**SUBJECT: COMANCHE PEAK STEAM ELECTRIC STATION (CPSES)
DOCKET NO. 50-445
RELIEF REQUESTS B-2 AND C-4 FOR THE UNIT 1 INSERVICE
INSPECTION (ISI) FROM 1986 EDITION OF ASME CODE,
SECTION XI, NO ADDENDA (INTERVAL START DATE: AUGUST
14, 2000, SECOND INTERVAL)**

**TXU GENERATION COMPANY LP
COMANCHE PEAK STEAM ELECTRIC STATION UNIT 1
FIRST TEN-YEAR INTERVAL ISI RELIEF REQUEST NO. C-4**

**TXU GENERATION COMPANY LP
COMANCHE PEAK STEAM ELECTRIC STATION UNIT 1
FIRST TEN-YEAR INTERVAL ISI RELIEF REQUEST NO. B-2**

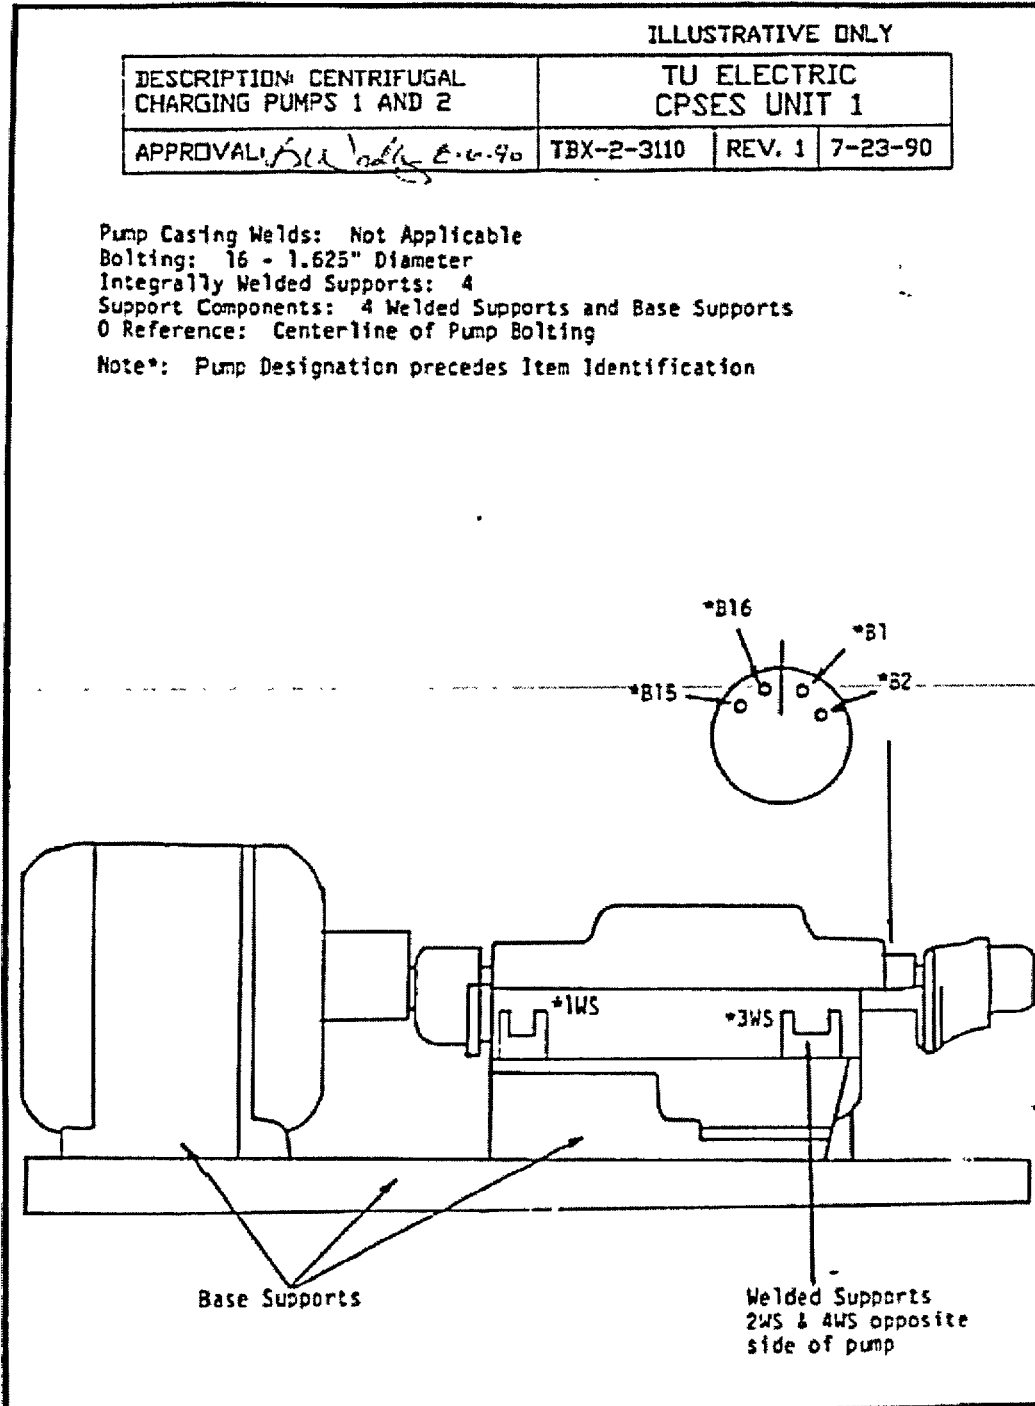
The examination coverage is limited due to interferences from the housing seal and pump base plate. Therefore, the Code required 100 percent surface examination by liquid penetrant method can not be achieved. Best effort examination resulted in coverage of approximately 77 percent of the area. It is impractical to obtain coverage of 100 percent required by the Code for each of the subject welds unless the CVCS Pump is redesigned to improve access to the welds.

The examination coverage is limited by area geometries of the CVCS pump housing seal and pump base plate, as indicated via the attached sketches on pages 3 and 4. These conditions make 100 percent examination impractical for these welds. To gain access for examination would require a design modification. Imposition of this requirement would be a significant burden on TXU Energy.

There are no proposed alternatives. TXU has examined a significant portion of these welds, obtaining approximately 77 percent of the required volumetric examination coverage. There was one recordable indication, which was a 7/32 inch rounded indication, identified by the liquid penetrant surface examination for Weld No. TBX-2-3110-4WS. This indication remained unchanged from the previous examination that was reported for the same weld in 1993, during the first 10-year interval for Unit 1. Based on this amount of coverage, it is reasonable to conclude that degradation, if present, would have been detected.

NOTES: REF. 1-2100 FOR ORIENTATION	DESCRIPTION: PRESSURIZER RELIEF	TU ELECTRIC
	1/SCH: (6) 719/7160, (3) 4387/160	CPES UNIT 1
	BRP: RC-1-RB-28A, RC-1-RB-15	INSERVICE INSPECTION
	FLOW: HI-0251	LOCATION ISOMETRIC
APPROVAL: <i>[Signature]</i> 7/2/90		TBX-1-1502 REV. 1 7-24-90

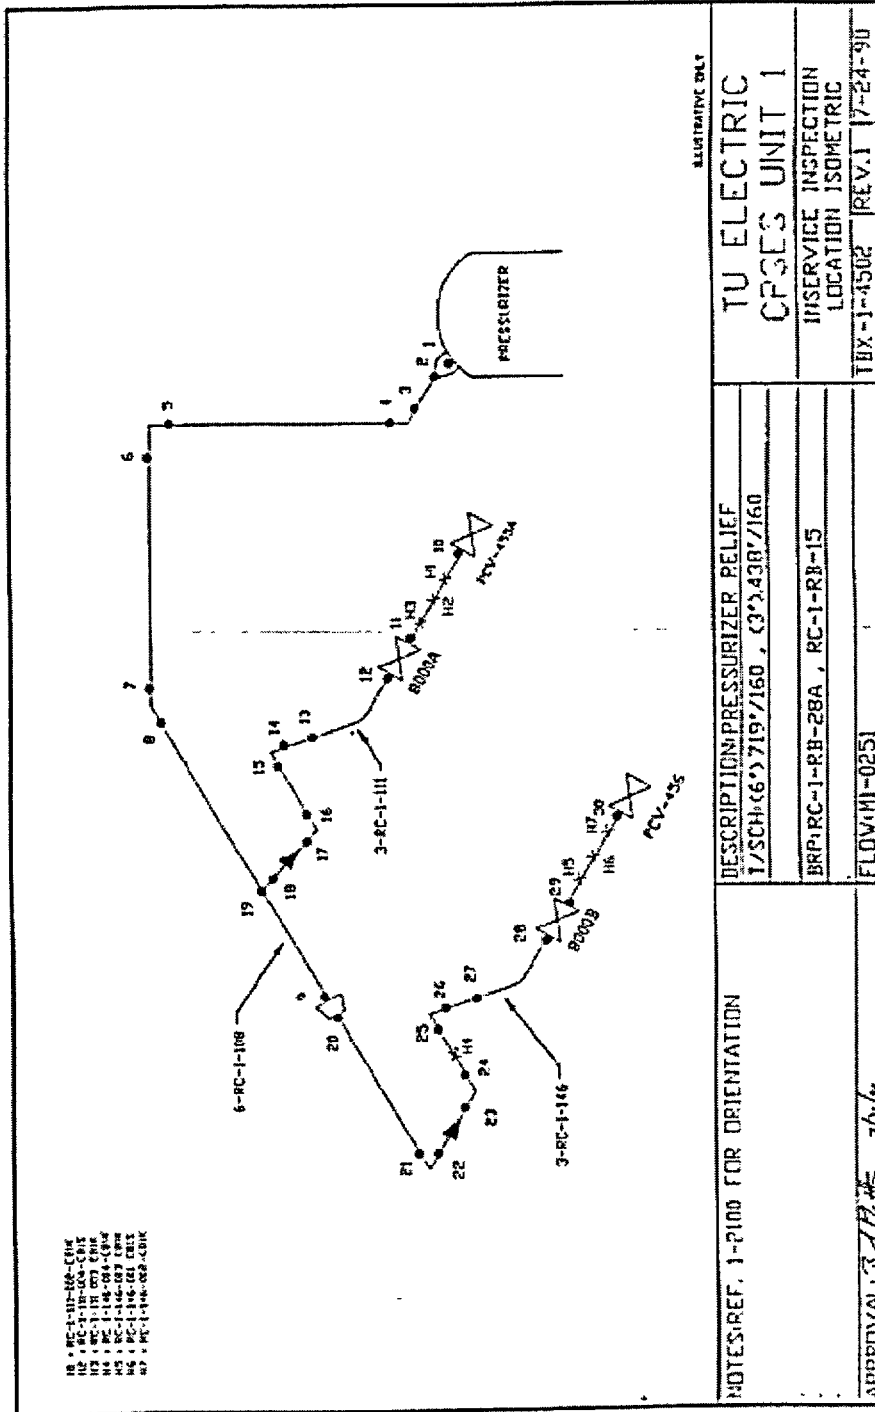
When the examination area is limited to one side of an austenitic weld, examination coverage does not comply with 10 CFR 50.55a(b)(2)(xv)(A) and proficiency demonstrations do not comply with 10 CFR 50.55a(b)(2)(xv)(B) and full coverage credit may not be claimed.

Pursuant to the requirements of 10 CFR 50.55a(g)(5)(iii), relief is requested from performing the required examination as required by 10 CFR 50.55a(b)(2)(xv)(A).

The best available techniques, as qualified through the Performance Demonstrative Initiative for Supplement 2 (67FR60520) with demonstrated best effort for single side examination, were used from the accessible side of the weld.
